**KNOXVILLE HISTORIC ZONING COMMISSION
STAFF REPORT - CERTIFICATE OF APPROPRIATENESS APPLICATION**

PROPERTY ADDRESS: 412 E Scott Ave 37917

FILE NO.: 2-B-18-HZ

LEVEL OF WORK: Level II. Major repair or replacement of materials or architectural elements (WINDOW INSTALLATION POSTPONED FROM 2/15/2018 HZC MEETING.)

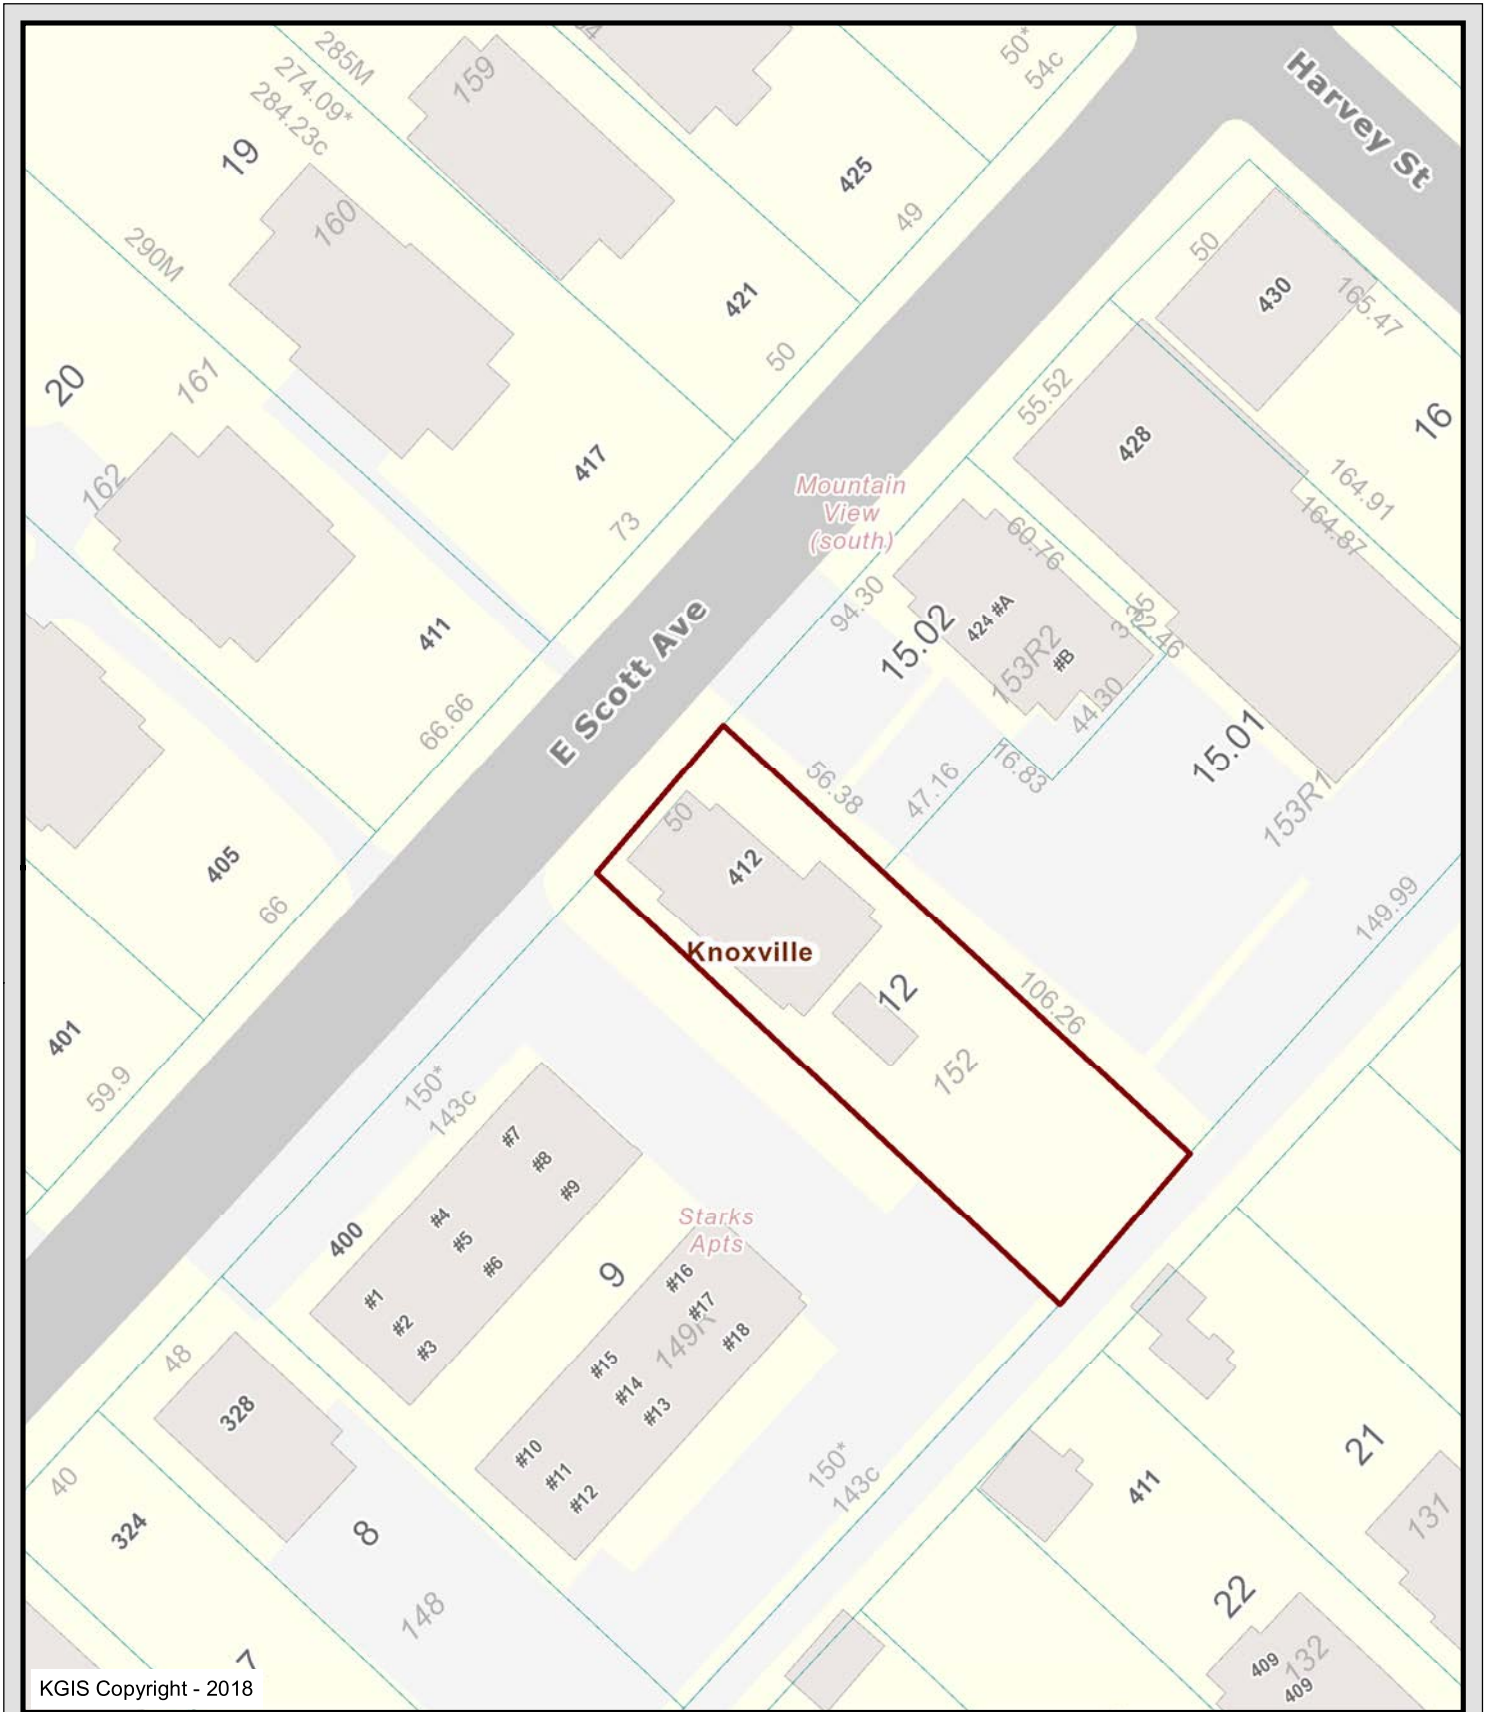
10) The diamond-shaped louvered attic vent in the north-side gable is an original and character-defining feature and should not be removed. To add a double-hung window in this location would be a historically inappropriate change that would be fully viewable from the public-right-of-way. A square window would be set apart as a modern installment.

- 1) Re-construct the two windows on the south side that were blocked in, based on earlier Google earth photo. Muntin pattern to be confirmed as appropriate.
- 2) Re-construct the south side upper-level window closest to front of house (westernmost) to be the same size as, and align with, the window to the east.
- 3) Install 1/1 wood windows to fit the original openings as indicated by the existing framing on all of the north side street-level windows.
- 4) Replace the small square double-hung window on the rear of the house toward the north side with square wood casement or stationary window. Consider aligning it with the window above.
- 5) Deny installation of 1/1 egress window in attic gable on north side.

412 Casement Egress Window

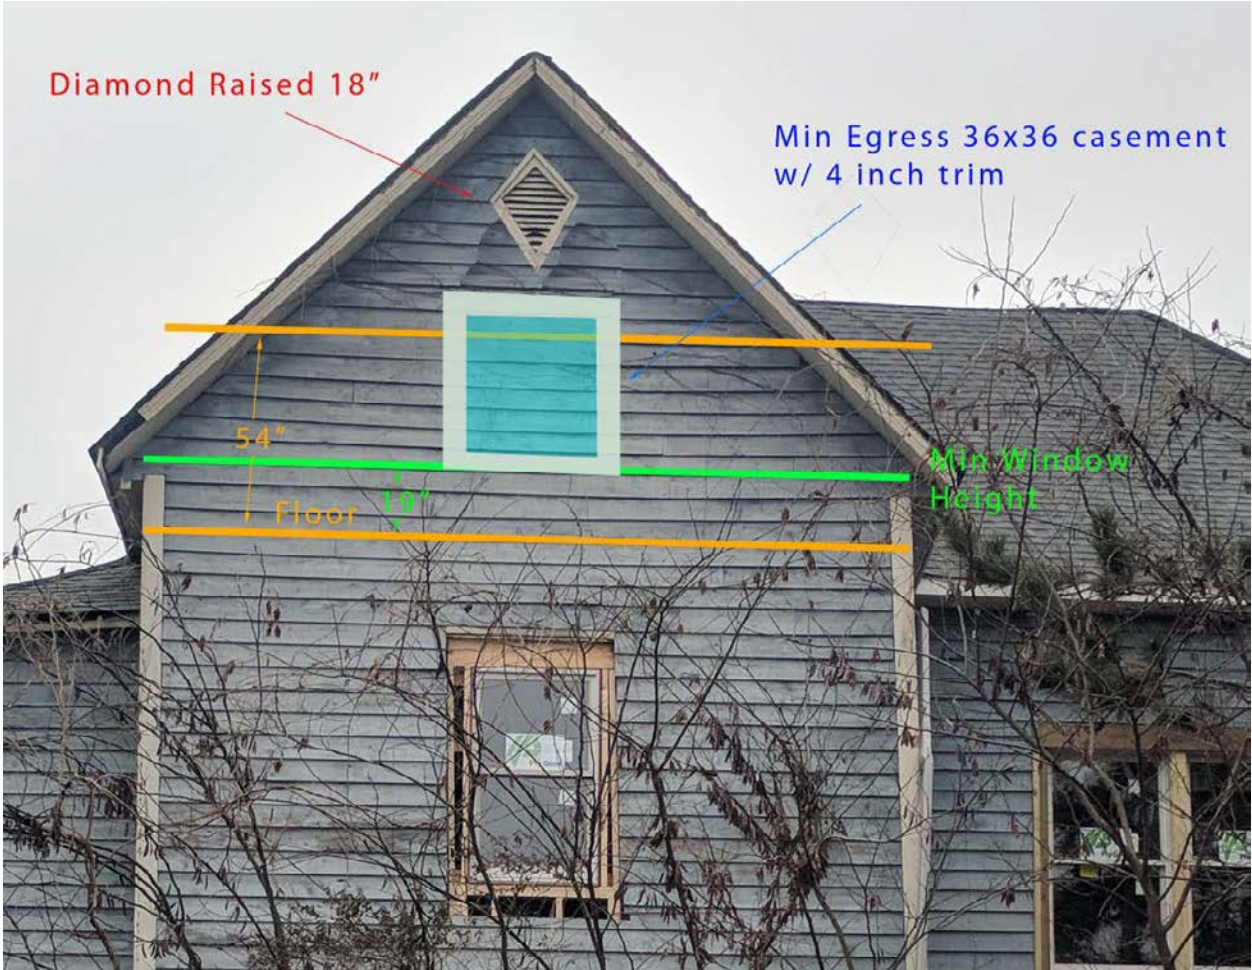
Current Condition - Existing Sawn Diamond lower tip is 54" from finished floor of attic level. For egress window, the bottom of the window has a minimum height of 19" above the finished floor.

To meet egress requirements, minimum square window frame size is 36"x36" for a casement style window. Accounting for the floor height minimum, and assuming 4 inch casing around the window, the window would overlap the existing sawn diamond feature.

Raising the sawn diamond effect 18" would allow the addition of the casement window while retaining the historic character of the sawn diamond.
